**TOWN OF HARVARD
PLANNING BOARD AGENDA
MONDAY, JANUARY 22, 2024 @ 7:00PM Revised**

**RE: 184 Ayer Road
Stormwater Site Plan Review
Harvard, MA**

Reference: Supplemental Peer Review -Stormwater Site Plan
184 Ayer Road
Harvard, Massachusetts
B+T Project No. 3241.05

SHEET NO. **C1.1**

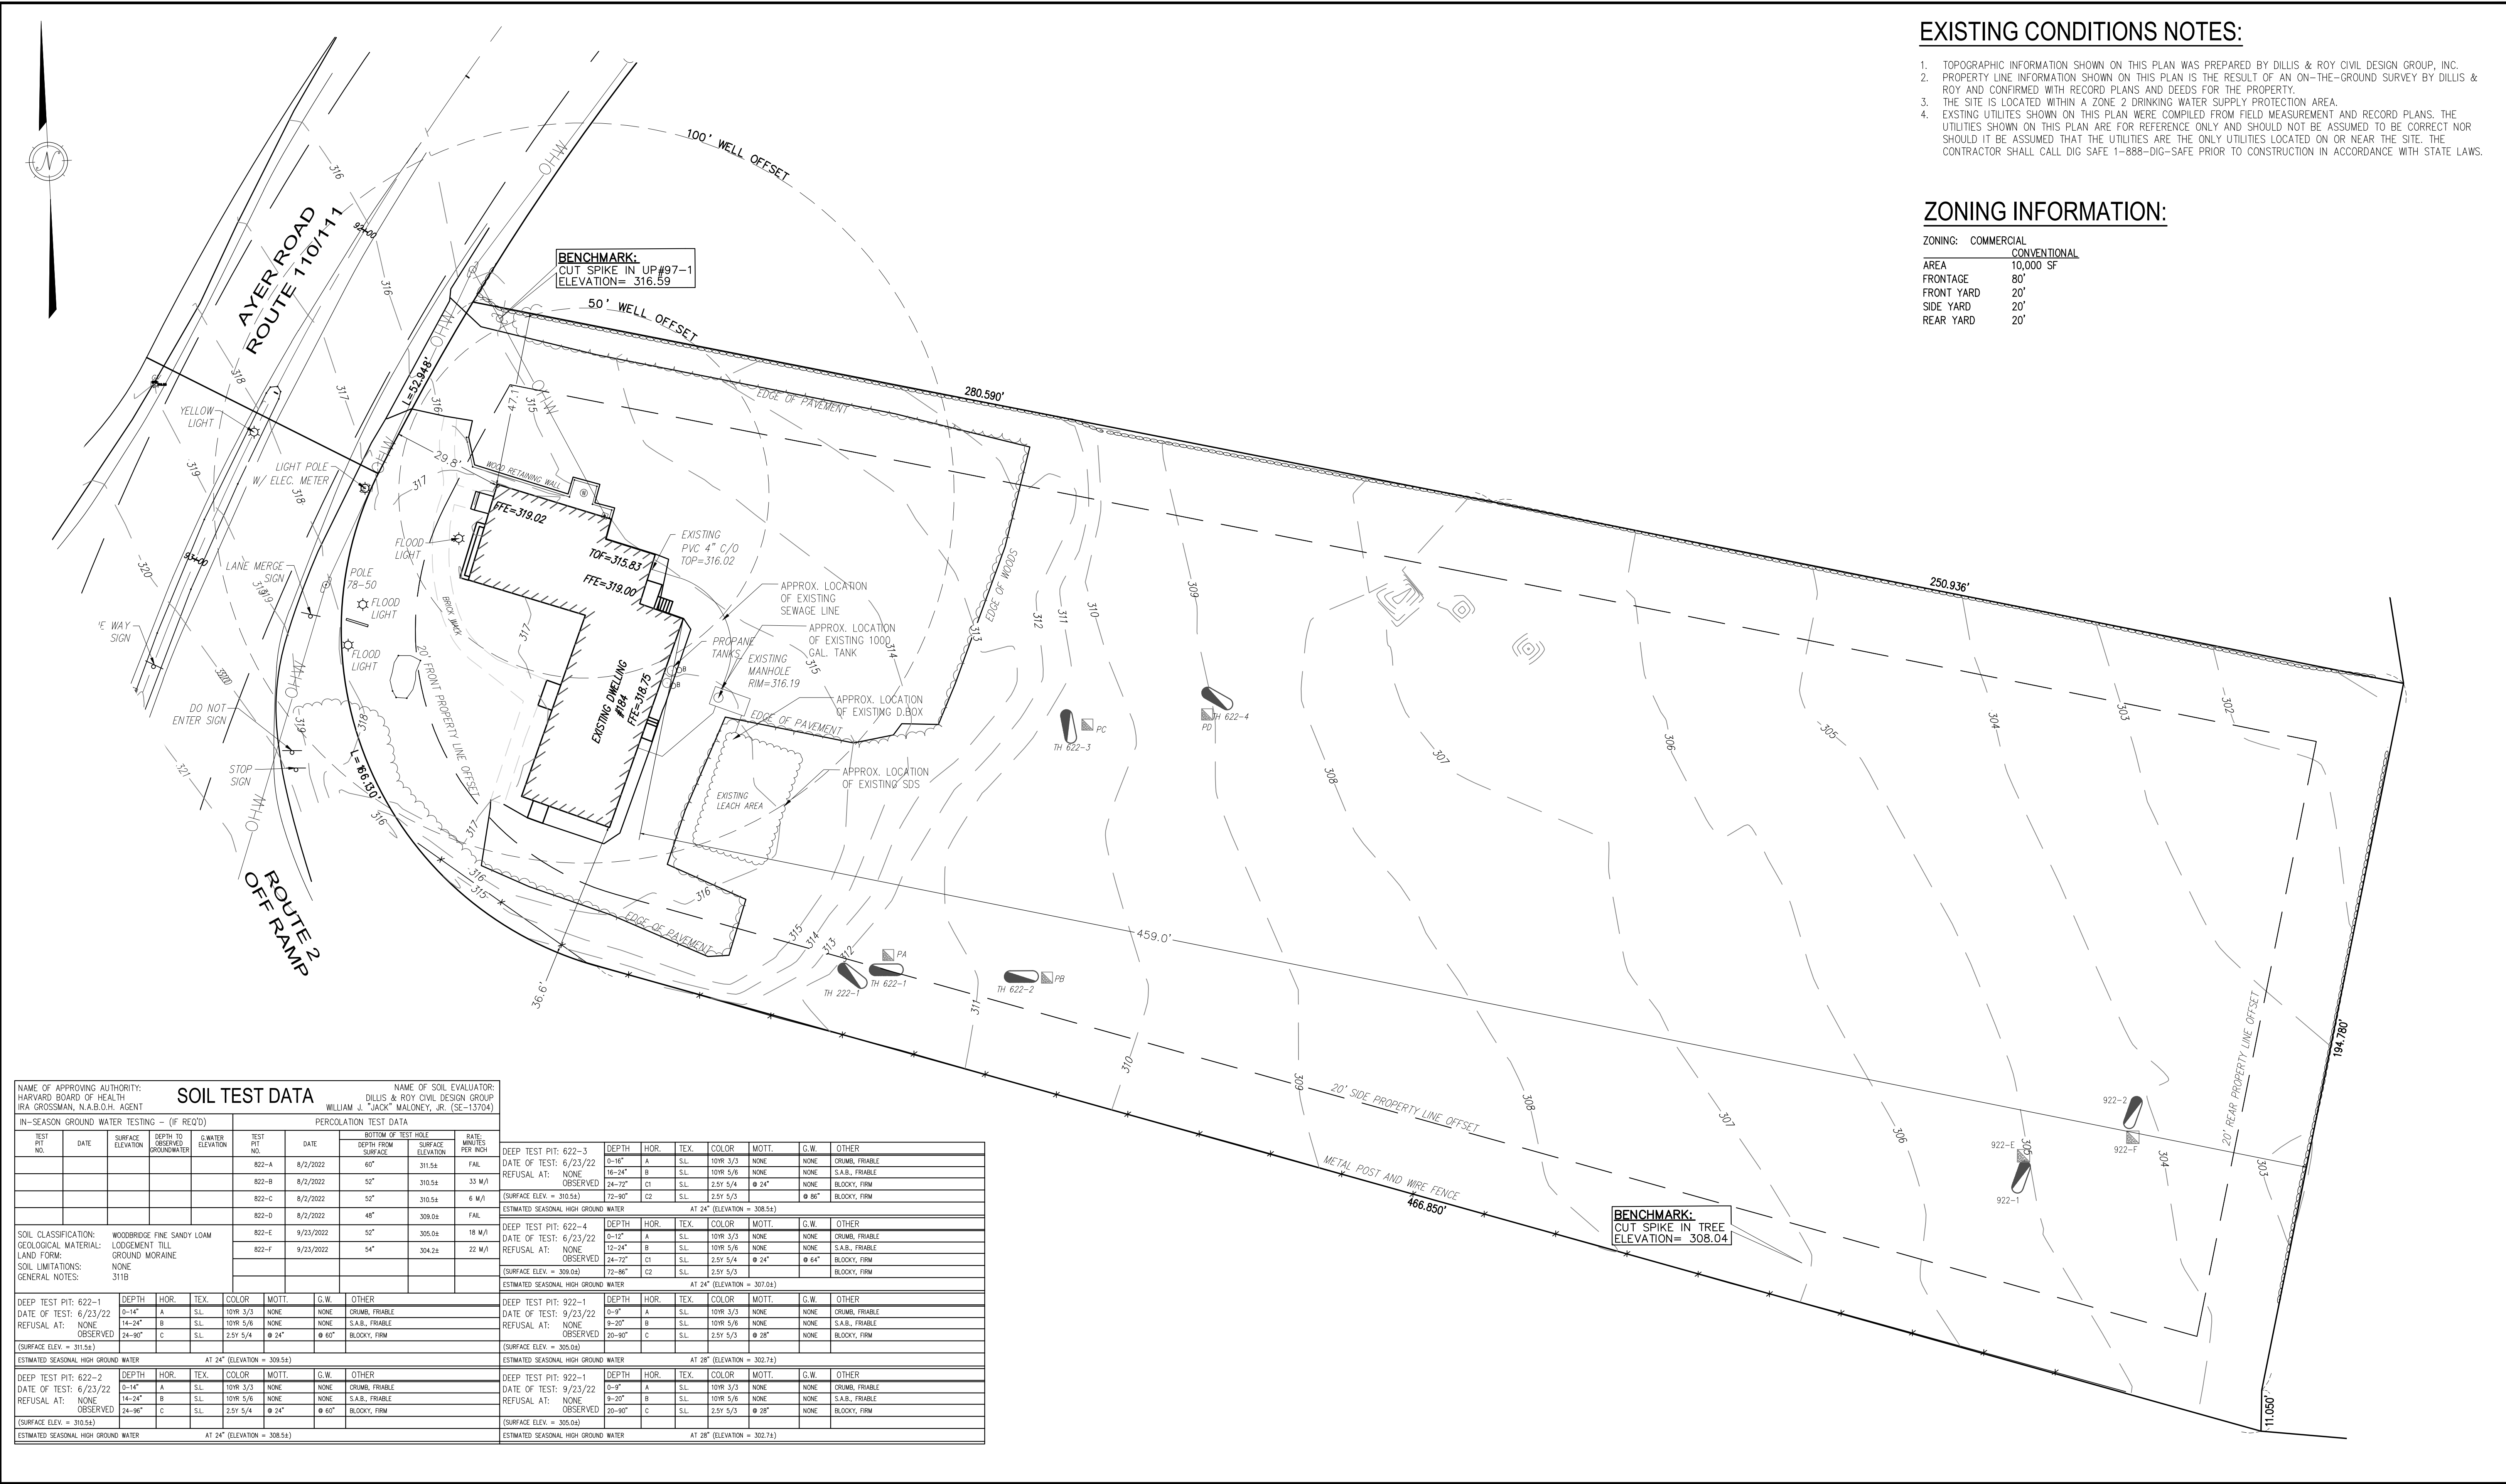
7. *Test pits appear to have been conducted based on symbology used on the existing conditions plan. This information has not been provided with stormwater report. We request that all available soil and estimated seasonal high groundwater elevation information be provided for review.*

7. Test pits appear to have been conducted based on symbology used on the existing conditions plan. This information has not been provided with stormwater report. We request that all available soil and estimated seasonal high groundwater elevation information be provided for review.

D&R – Evidence provided by the on-site soil testing (Sheet C1.1) shows that the western portion of the site is underlain by a high groundwater table. ESHGW was observed at 24” which limits the ability to provide required offsets for infiltration, per Mass DEP Stormwater Manual. Additionally, the reconfigured impervious parking area results in a net reduction of impervious coverage within the delineated HSG-A area (per web soil survey).

D&R – Plan Sheet C1.1 has been revised to include test pit data.

Applicant's Response: Plan Sheet C1.1 has been revised to include test pit data.

SHEET NO. **C2.0**

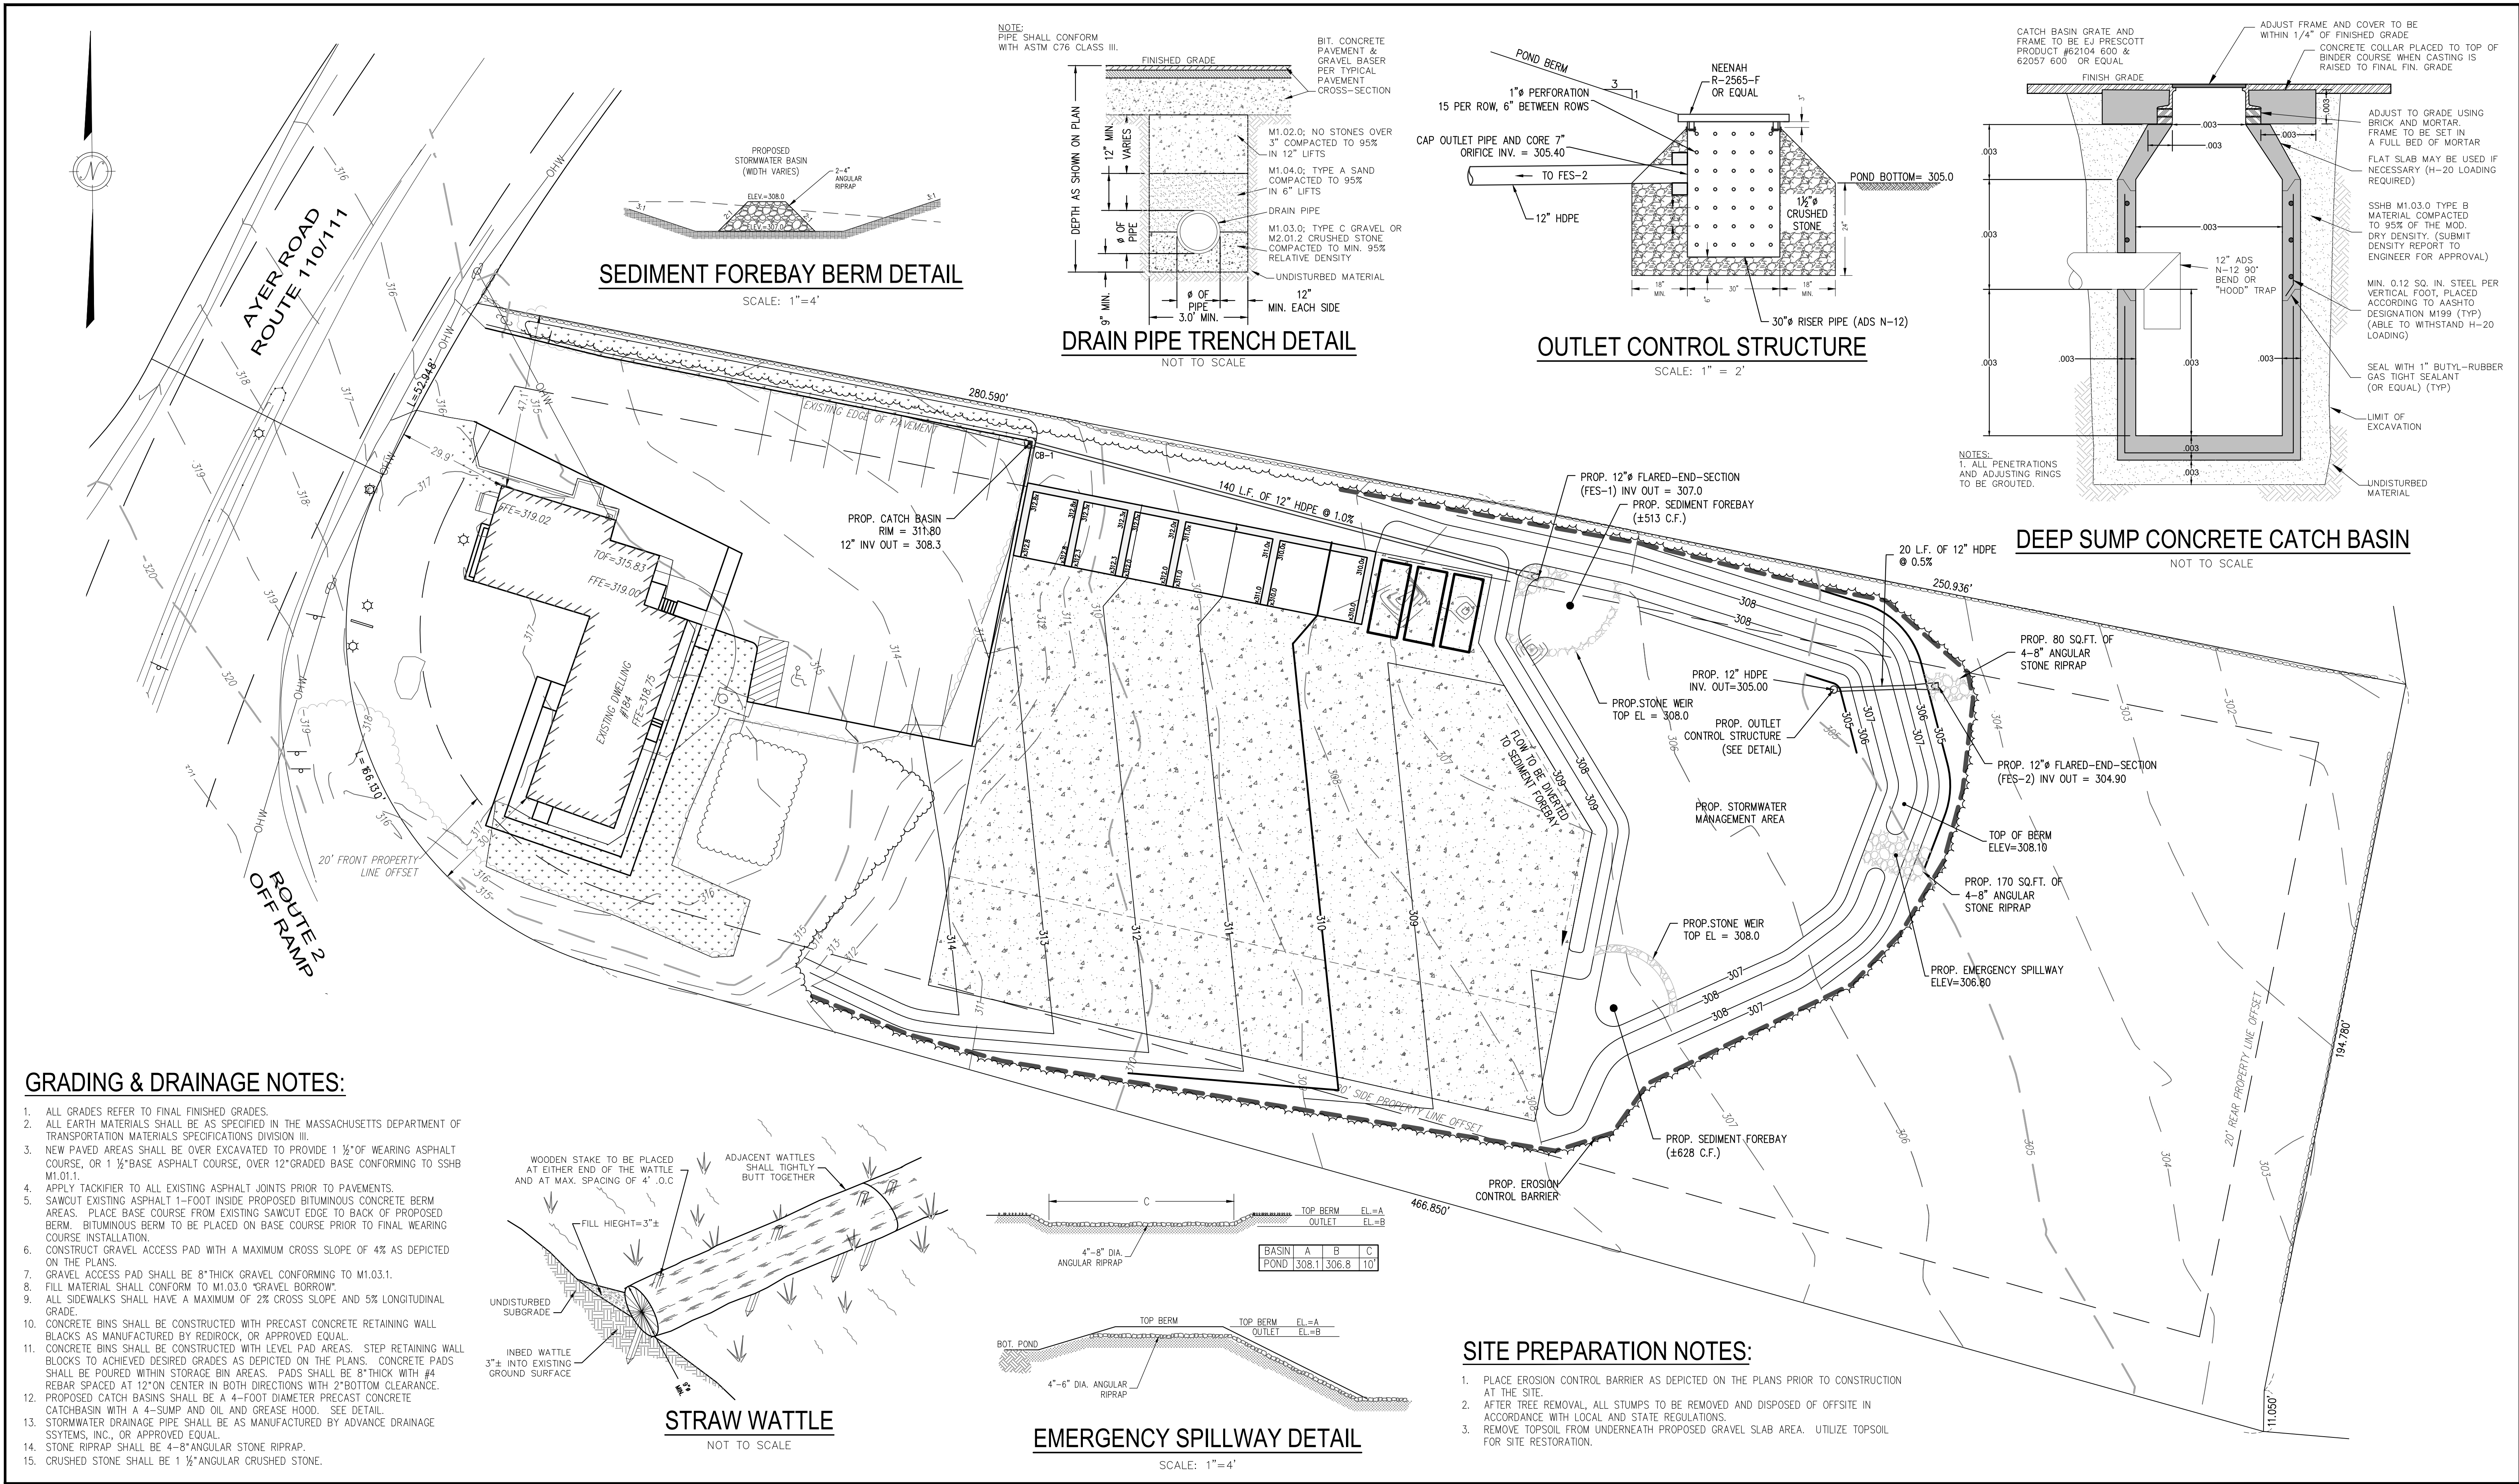
8. *The long-term pollution prevention plan indicates that snow storage areas are depicted within the plan set. These areas do not appear to be included as indicated. We request that the Applicant clarify protocols for snow storage and removal.*

8. The long-term pollution prevention plan indicates that snow storage areas are depicted within the plan set. These areas do not appear to be included as indicated. We request that the Applicant clarify protocols for snow storage and removal.

D&R – Plan Sheet C2.0 has been revised to depict locations for snow storage on-site.

Applicant's Response: Plan Sheet C2.0 has been revised to depict locations for snow storage on-site.
